**New Albany Architectural Review Board Meeting Agenda**  
Monday, April 10, 2023 7:00pm

**ARB-40-2023 Certificate of Appropriateness**

**New Albany Architectural Review Board**  
Monday, March 13, 2023 DRAFT Meeting Minutes

**Architectural Review Board Staff Report  
March 13, 2023**

**266 E. MAIN STREET CANOPY ADDITION  
CERTIFICATE OF APPROPRIATENESS**

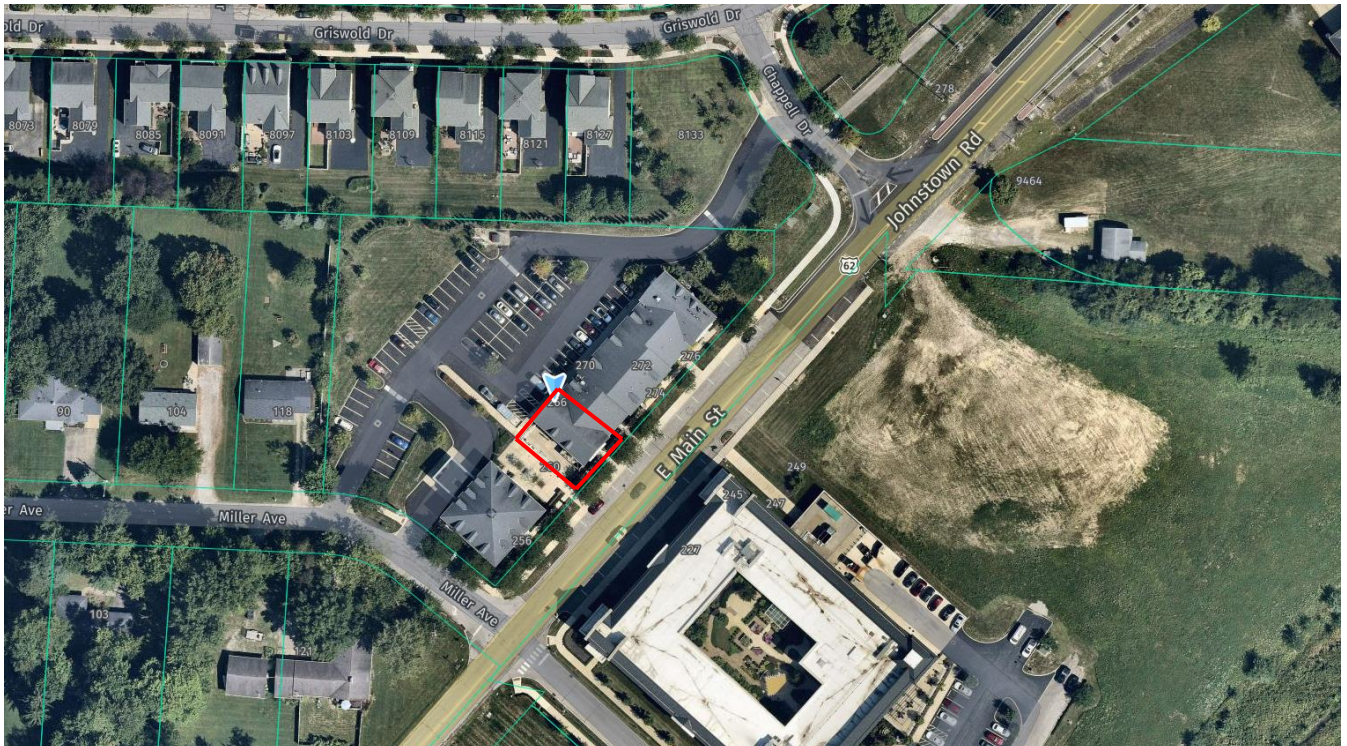
Board Member Moore further agreed and asked whether the top of the canopy would reach the underside of the brick.

Board Member Davie stated that he was a big fan of Elliot's and looked forward to this amenity and asked whether the downspout would be relocated.

Board Member Davie asked whether the existing smaller canopy would be removed and how the new canopy would be attached.

Frank Weaver, on behalf of the applicant, responded in the affirmative and stated that it might not be clear from the rendering but that was his intention.

Mr. Weaver responded no, that the downspout was close to the corner.

Mr. Weaver responded that the smaller canopy would be removed and the new canopy would be installed using a pre-fab system and there would be a flashing detail as it goes up to the metal roof.

Site Plan

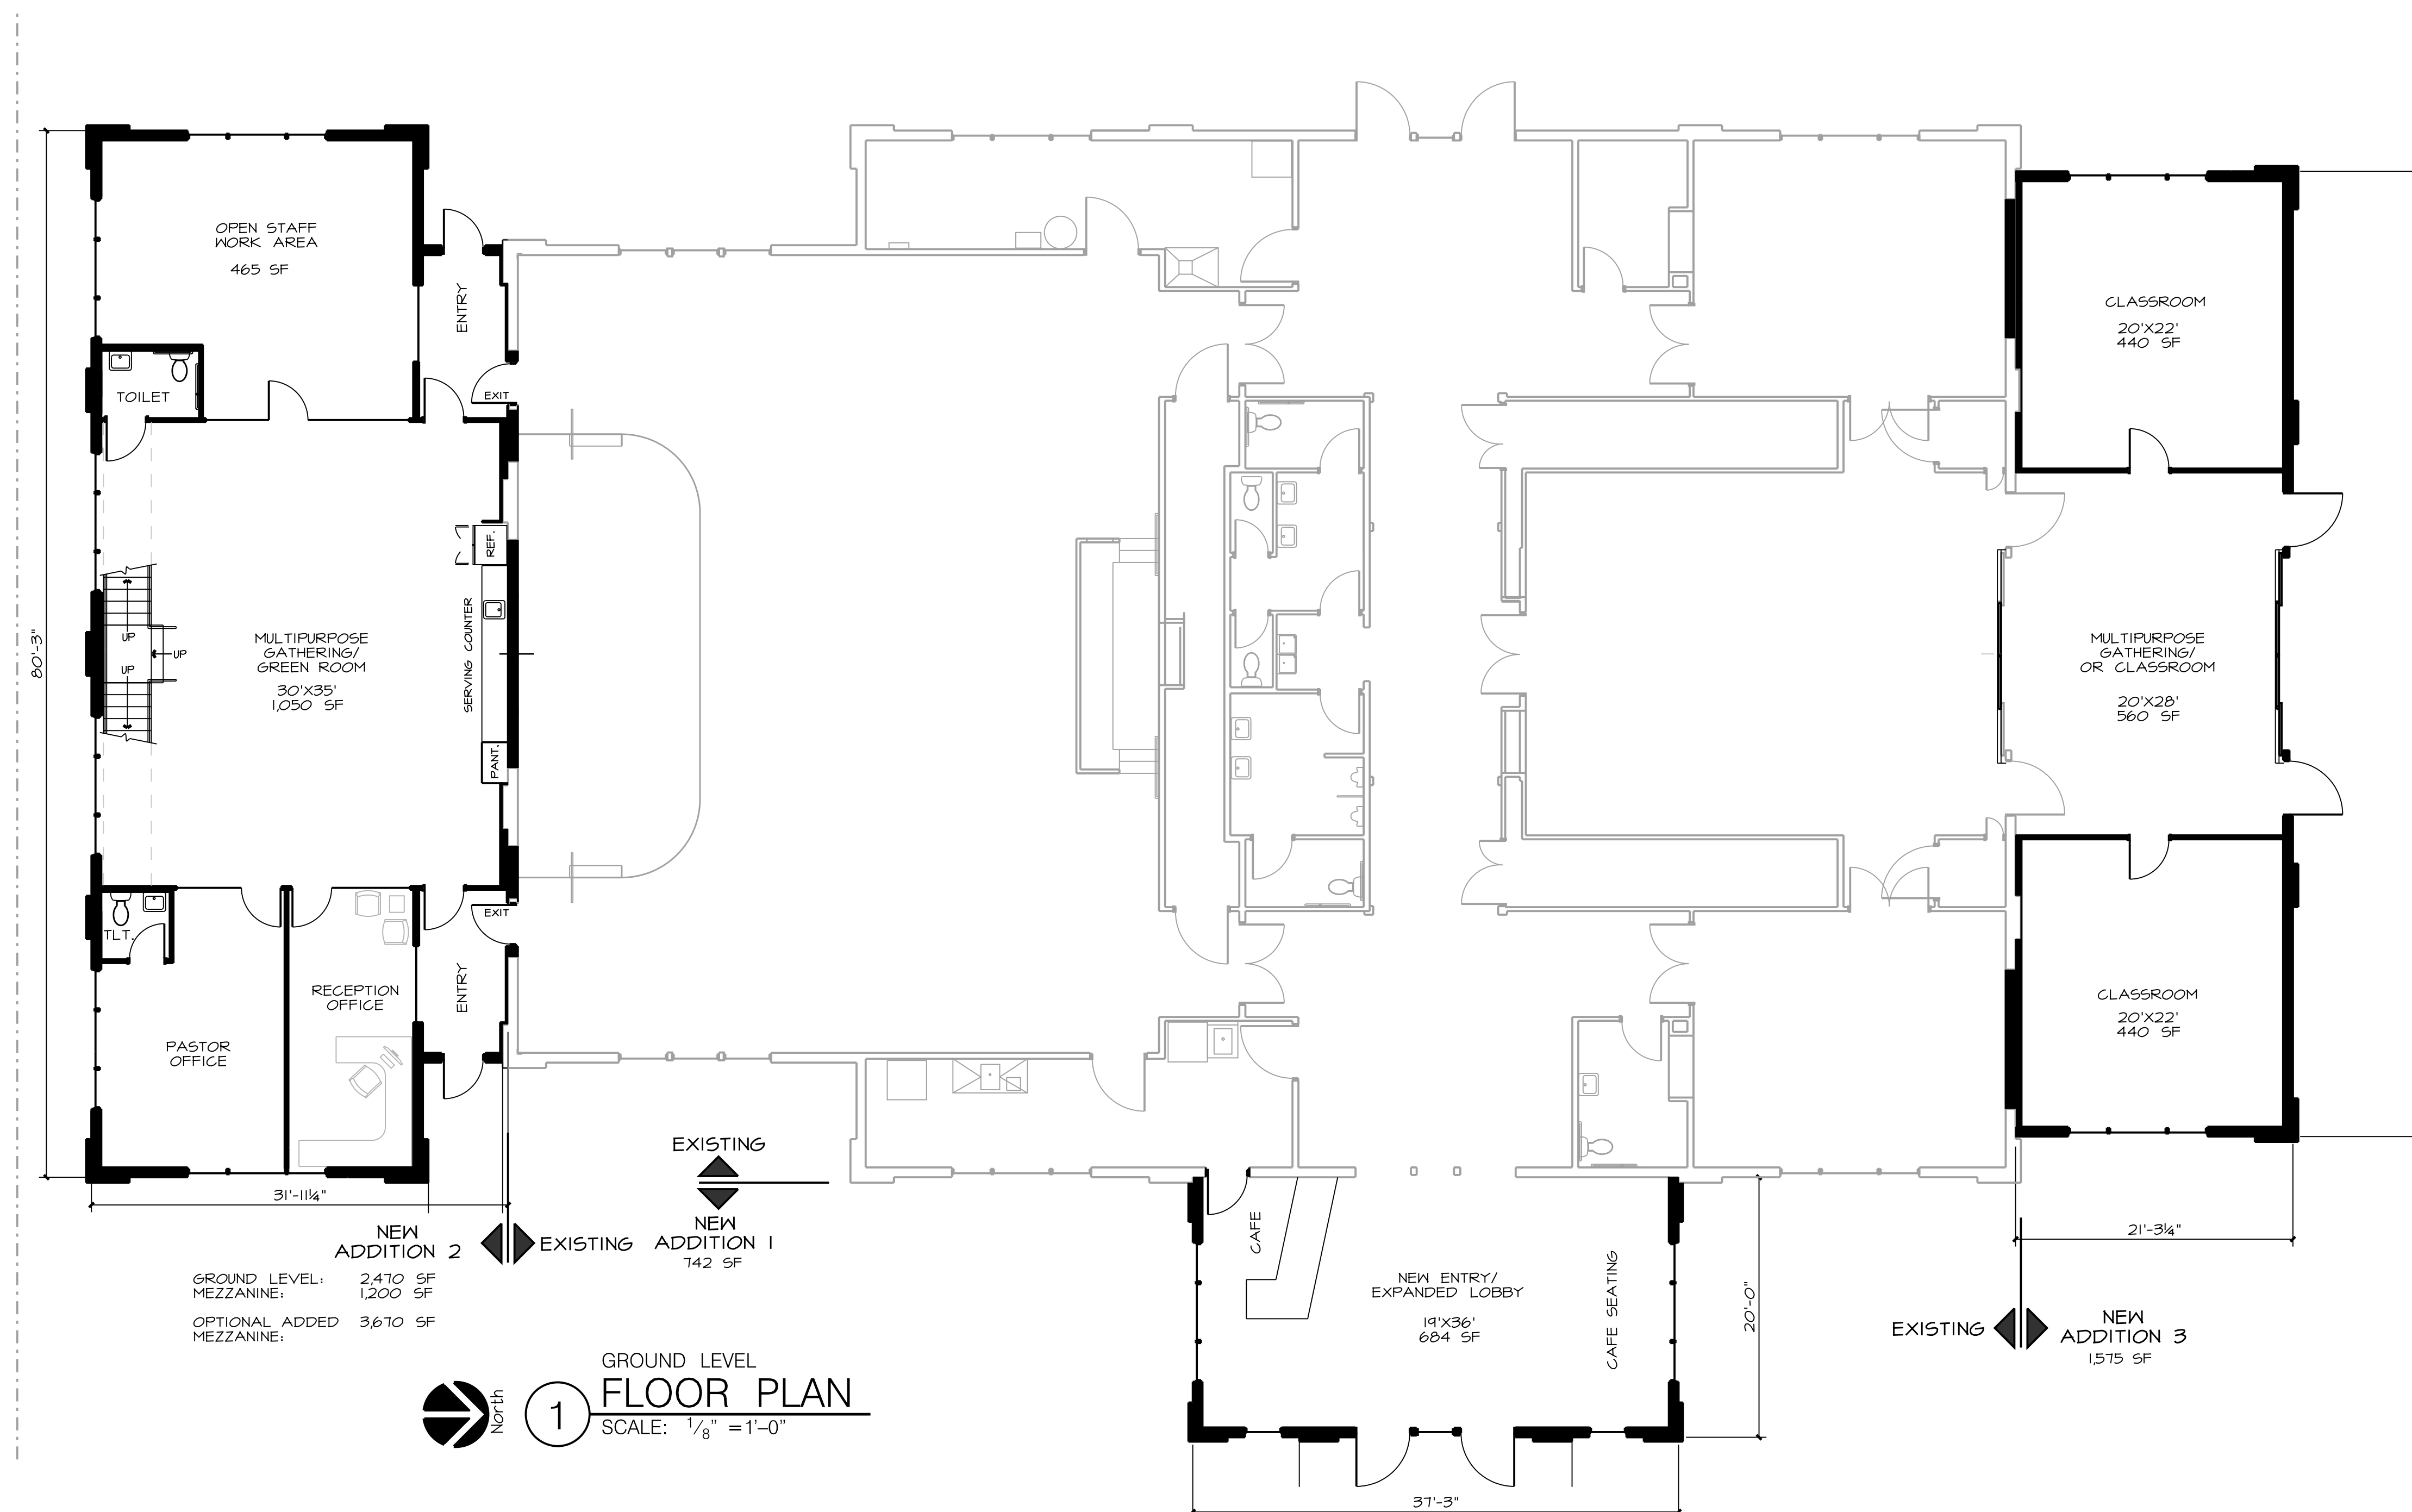
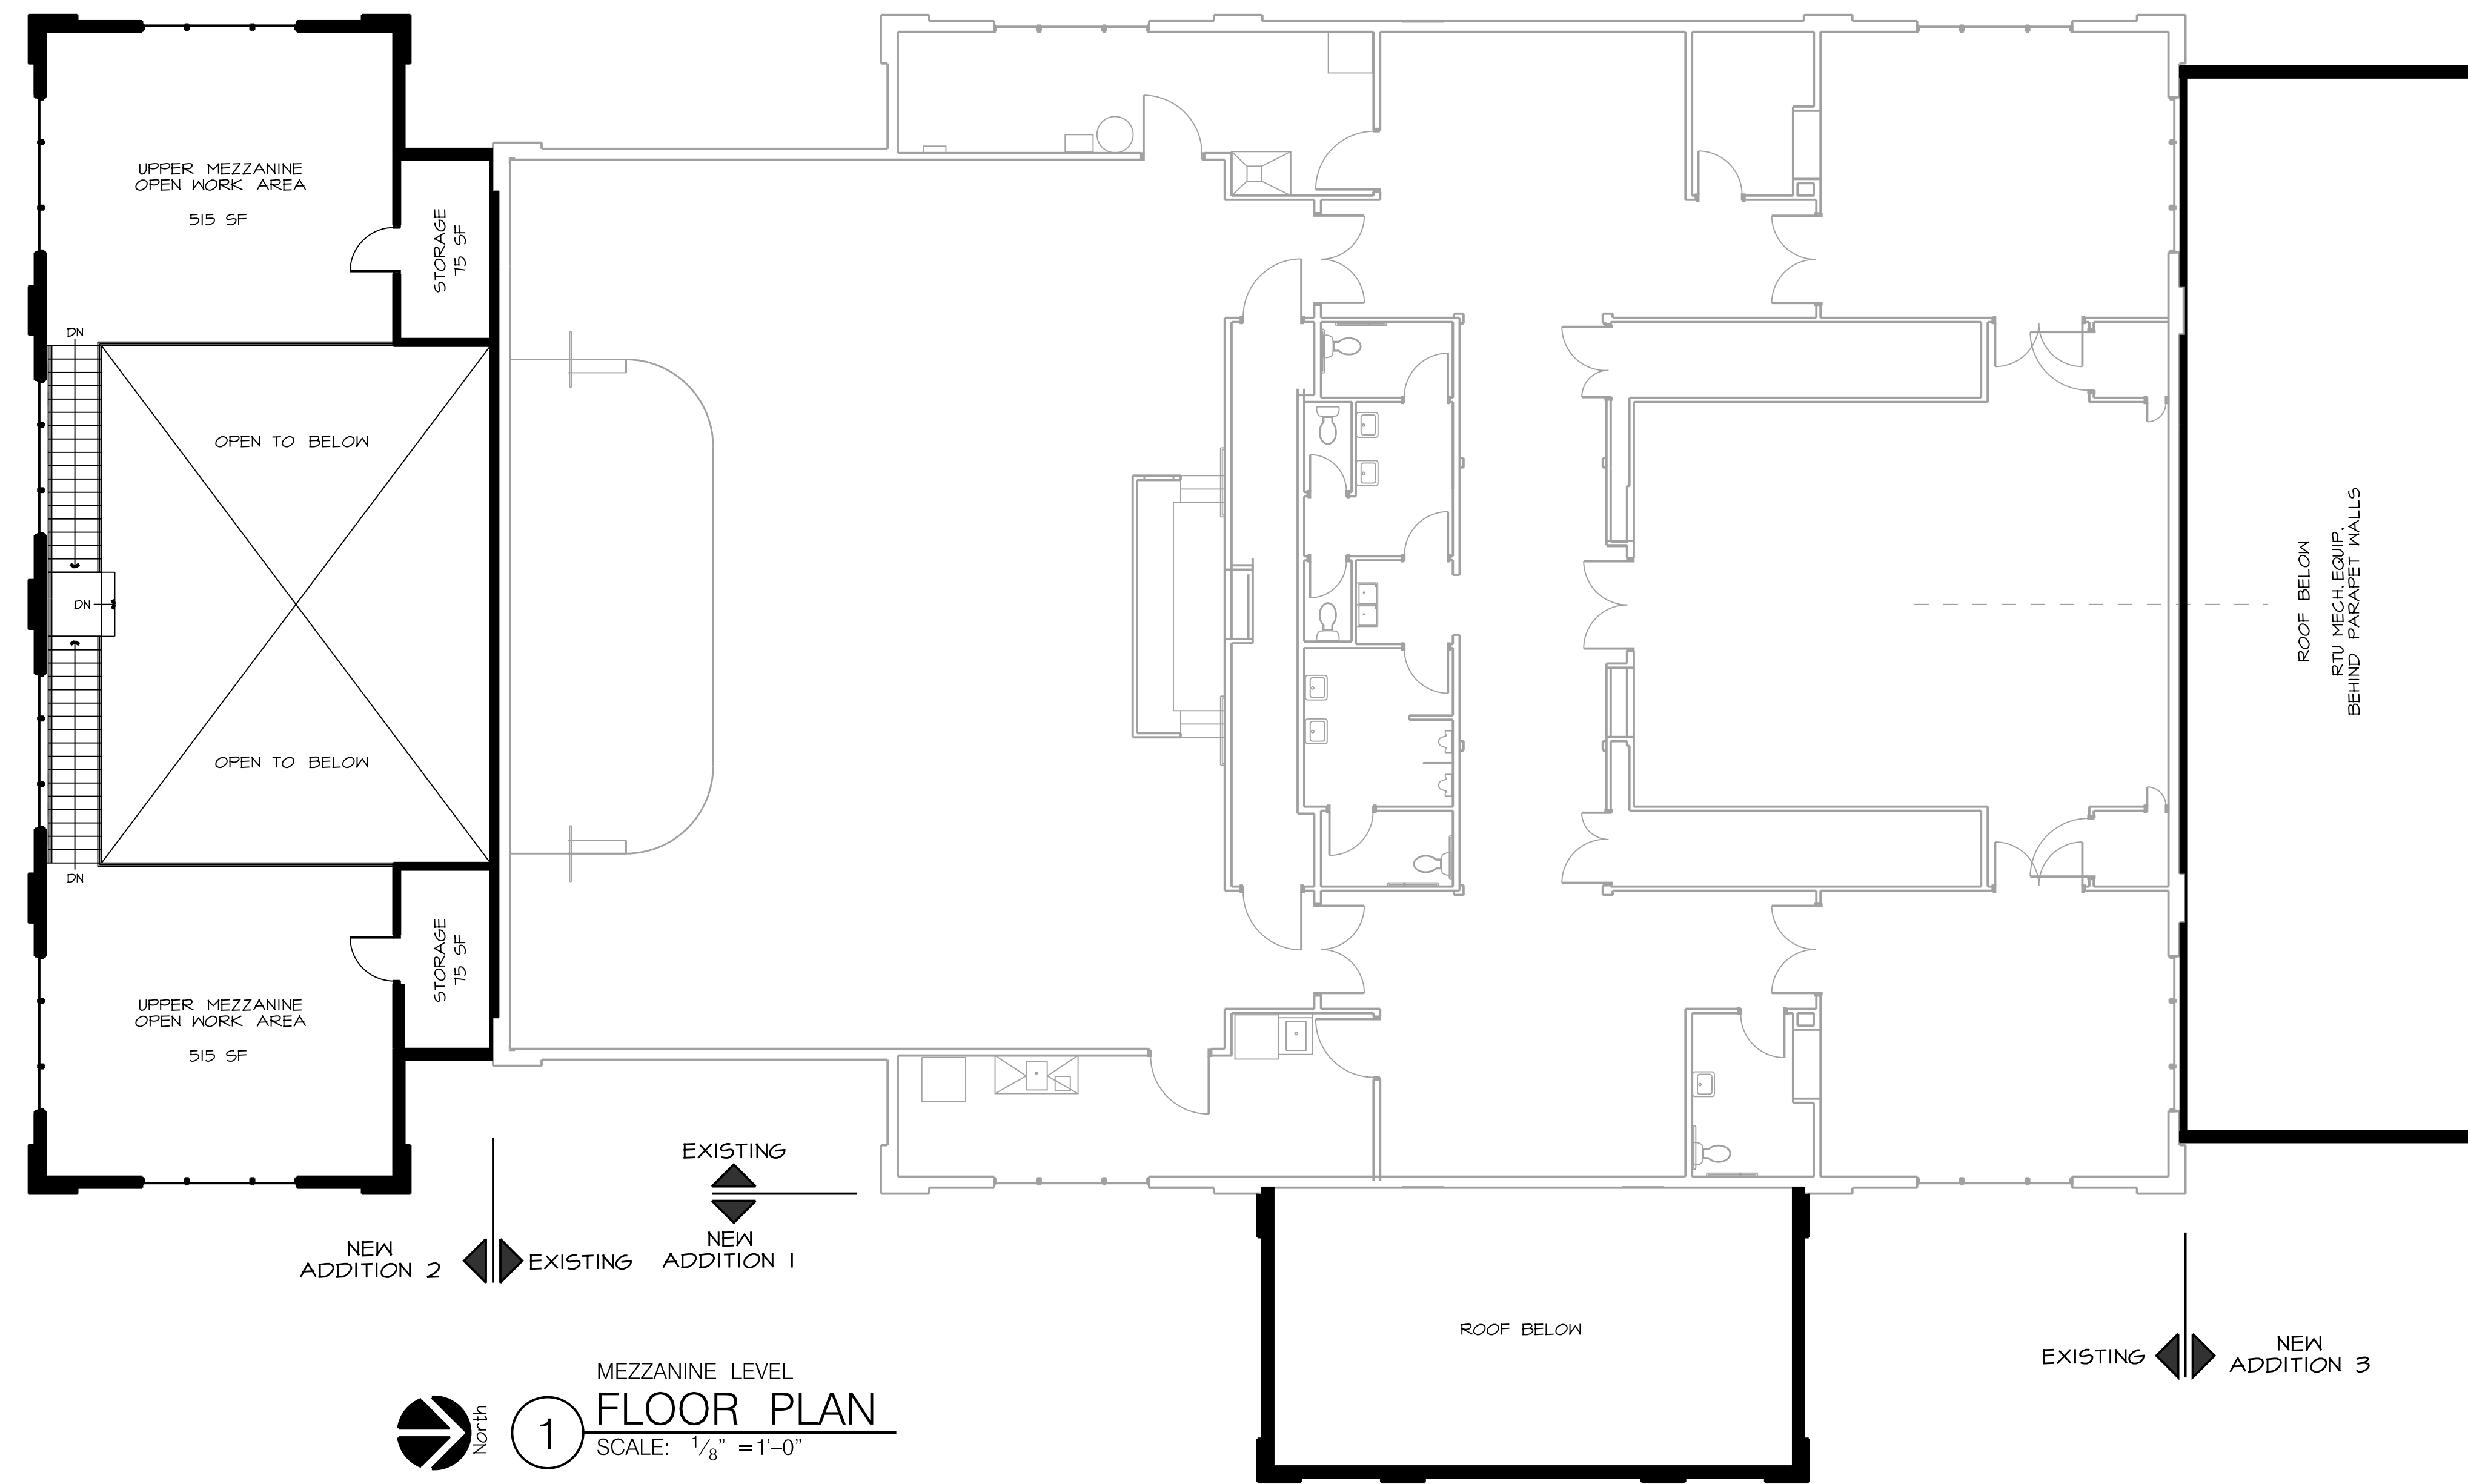
1. That the windows provide simulated divided light 2” grids and a shadow bar between the glass to match the existing windows on the existing building.
